CITY OF AVONDALE

GENERAL ENGINEERING REQUIREMENTS

AMENDMENT

June 30, 2025

DETAIL NO. <h2 style="margin: 0;">A1650</h2>	STANDARD DETAIL	<h1 style="margin: 0;">FLOOD CONTROL DISTRICT LEVEE MULTI-USE PATH</h1>	APPROVED BY: <i>[Signature]</i> DATE: 5/14/2025
---	-----------------	---	--

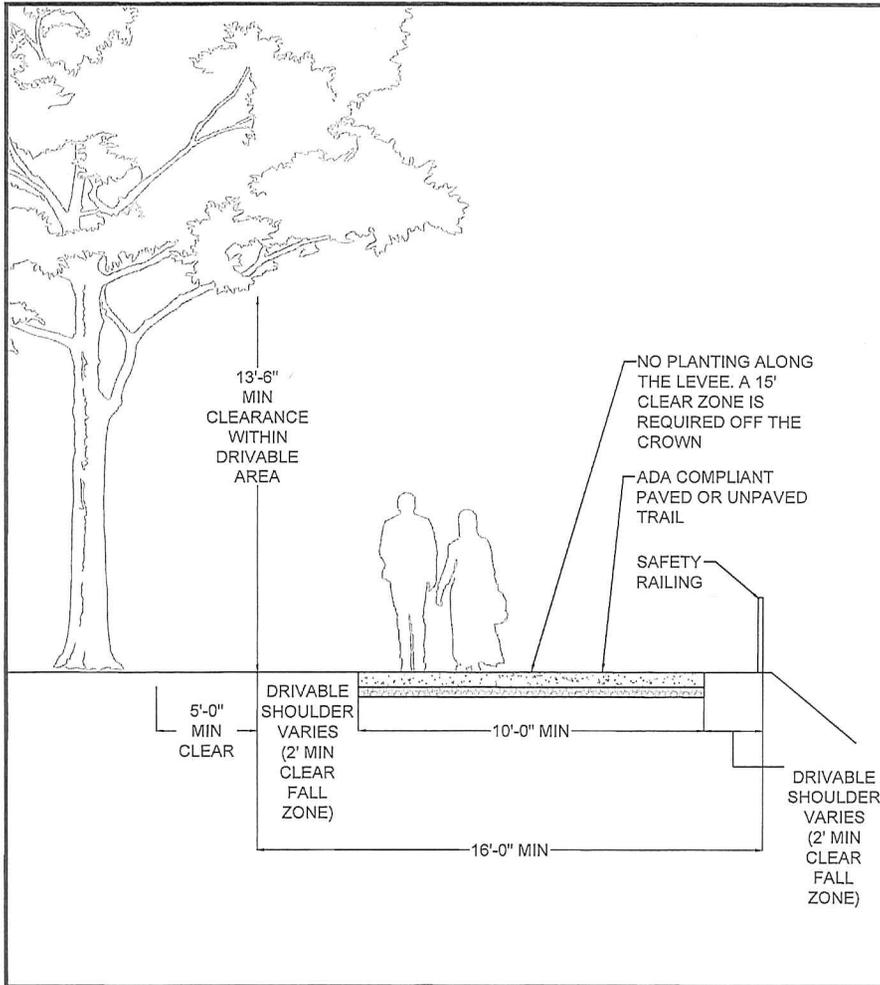
- A. 1600 Series of Details is hereby amended to include new details for Flood Control District Levee Multi-Use Path, Paved Multi-Use Path with 20' Easement/ RW, Unpaved Multi-Use Path with 20' Easement/ RW, and Back Country Multi-Use Path, 7'- 8' in Exhibit "A", as attached, and summarized as follows:
- i. Standard Detail A1650 Flood Control District Levee Multi-Use Path
 - ii. Standard Detail A1651 Paved Multi-Use Path with 20' Easement/ RW
 - iii. Standard Detail A1652 Unpaved Multi-Use Path with 20' Easement/ RW
 - iv. Standard Detail A1653 Back Country Multi-Use Path, 7'- 8'

APPLICANT MUST VERIFY WITH FLOOD CONTROL DISTRICT OF MARICOPA COUNTY THE FOLLOWING:

- PAVED TRAIL SHOULD BE 6" DEPTH CLASS 8 CONCRETE SLURRY ON 4" BASE MATERIAL WITH SAW-CUT JOINTS, OR 3" DEPTH ASPHALT CONCRETE OVER 4" AGGREGATE BASE COURSE
- DEPTH OF SECTION IS ULTIMATELY PER GEOTECHNICAL REPORT (DETERMINE THICKNESS BASED ON LOAD FOR EMERGENCY VEHICLE ACCESS)
- DRIVABLE SHOULDER SHOULD BE PAVED OR COMPACTED AGGREGATE BASE COURSE (SUB-BASE SOILS SHOULDER BE COMPACTED TO 95% (MIN) STANDARD PROCTOR)

- INSTALL 4'-8" HEIGHT SAFETY RAILING WHERE SHOULDER IS 5' OR LESS, PER FLOOD CONTROL DISTRICT STANDARD DETAIL 145-1, WITH TYPE 4 FOOTINGS
- A CLEARANCE HEIGHT OF 13'-6" SHOULD BE MAINTAINED ABOVE DRIVABLE AREA (16' MIN DRIVABLE WIDTH, PER DETAIL). KEEP 5' MIN CLEARANCE BETWEEN DRIVABLE ZONE AND TREE TRUNKS.

- CROSS SLOPE IS 2% MAX
- TYPICAL LONGITUDINAL SLOPE IS 5% MAX
- DESIGN PER ADA REQUIREMENTS
- A POTENTIAL SLOPE EASEMENT MAY NEED TO BE REQUIRED
- SLOPES WITHIN FALL ZONE CANNOT EXCEED 6:1
- NOTE: NO TREES TO BE PLANTED ON BACK SLOPES OF LEVEES

- IF THE SIDE SLOPE IS A VERTICAL DROP TO A 2:1 SLOPE, INSTALL A PIPE RAIL WITH ATTACHED CHAIN LINK FABRIC OR OTHER RESTRICTION TO PROTECT AGAINST FALL HAZARDS.
- IF THE SIDE SLOPE FALLS BETWEEN 2:1 AND 6:1 SLOPE, INSTALL PIPE RAIL ONLY, UNLESS SLOPE PRESENTS OTHER HAZARDS.
- IF THE SIDE SLOPE FALLS BETWEEN 6:1 AND A FLAT AREA, NO PIPE RAIL IS REQUIRED (UNLESS NOTED OTHERWISE BY DISTRICT STAFF)

**TRAFFIC CALMING
GENERAL NOTES**

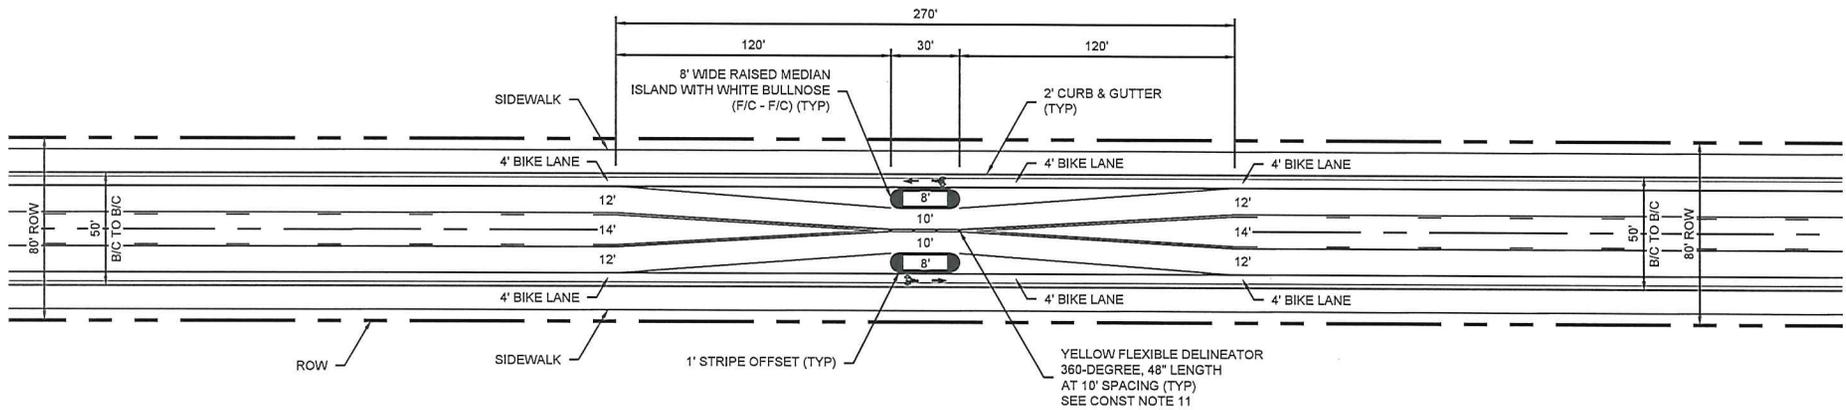
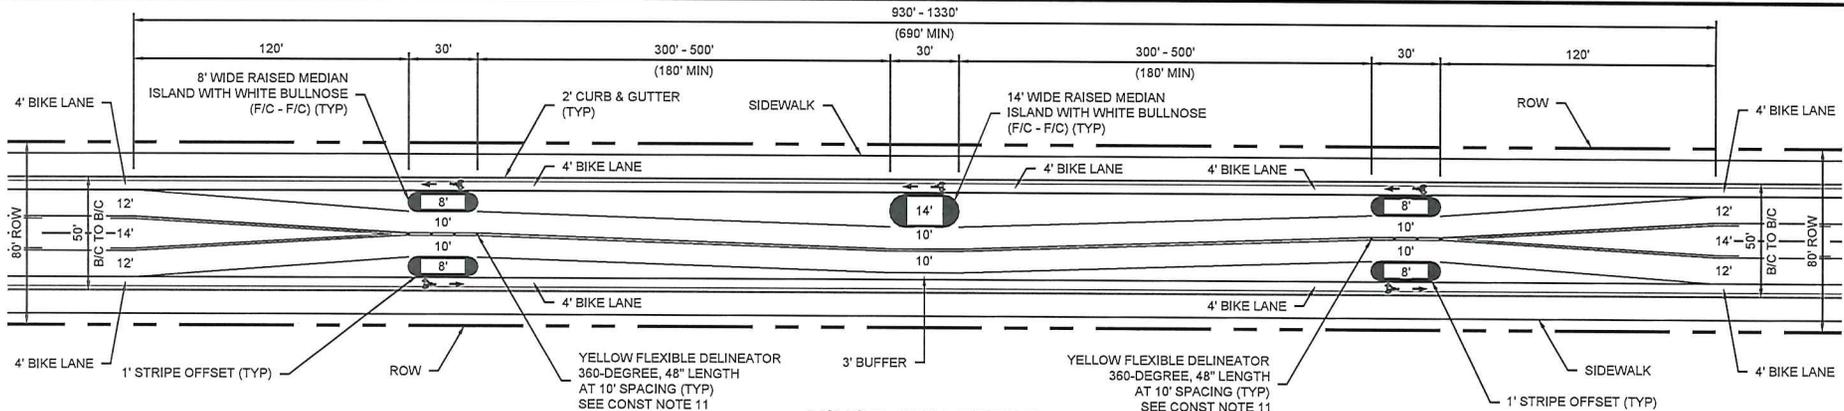
- i. Standard Detail A1215-1 Traffic Calming General Notes
- ii. Standard Detail A1215-2 Traffic Calming Choker
- iii. Standard Detail A1215-3 Traffic Calming Lateral Shift – Single
- iv. Standard Detail A1215-4 Traffic Calming Lateral Shift – Double
- v. Standard Detail A1215-5 Traffic Calming Lateral Shift – w/ Median
- vi. Standard Detail A1215-6 Traffic Calming Bi-Directional Choker

1. TAPER RATES BASED ON 30 MPH POSTED/DESIGN SPEED. ALL DIMENSIONS ARE FROM CENTER OF STRIPE TO CENTER OF STRIPE AND TO FACE OF CURB UNLESS OTHERWISE NOTED.
2. TYPICAL MINOR COLLECTOR STREET SECTION WITH 80' ROW PER COA DETAIL A1102
3. CALMING MEASURE SHALL NOT BE PLACED OVER MANHOLES, WATER VALVES, SURVEY MONUMENTS, JUNCTION CHAMBERS, IN CONFLICT WITH DRIVEWAYS, OR ADJACENT TO FIRE HYDRANTS.
4. CONTRACTOR MUST PROVIDE VERIFICATION OF CROSS-SECTION DIMENSIONS.

1. ALL CONSTRUCTION SHALL COMPLY WITH THE CURRENT CITY OF AVONDALE MAG SUPPLEMENT AND MAG STD DETAILS AND SPECIFICATIONS AS APPLICABLE.
2. ALL BASE COURSE MATERIAL SHALL CONFORM TO MAG STD SPECIFICATIONS, SECTIONS 310 AND 702.
